Authorized Field Change

**AFC 13910****Date:** March 2013**Subject File:** CAB**Subject:** Blower Motor Assemblies and Linear Power Module (LPM) Updates

On some ProStar® Sleeper vehicles the front HVAC blower motor may fail to start after the vehicle has sat for a period of time. This Service Procedure is divided into two sections: "Replacement of Blower Assembly and LPM with Installation of Tape Seal", and "Replacement of LPM only".

Figure 2. Tape Adhered Between Evaporator and Black Plastic Case of Interior Module

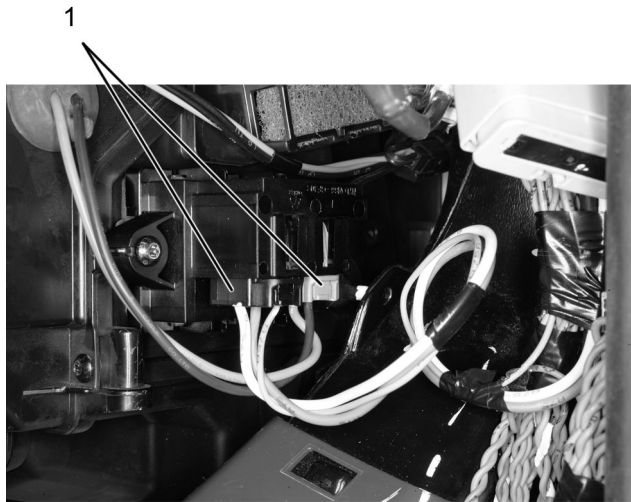
9. Fold tape lengthwise and apply tape to cover gap between gaskets (Figure 1, Item 1) on top of evaporator (Figure 2).
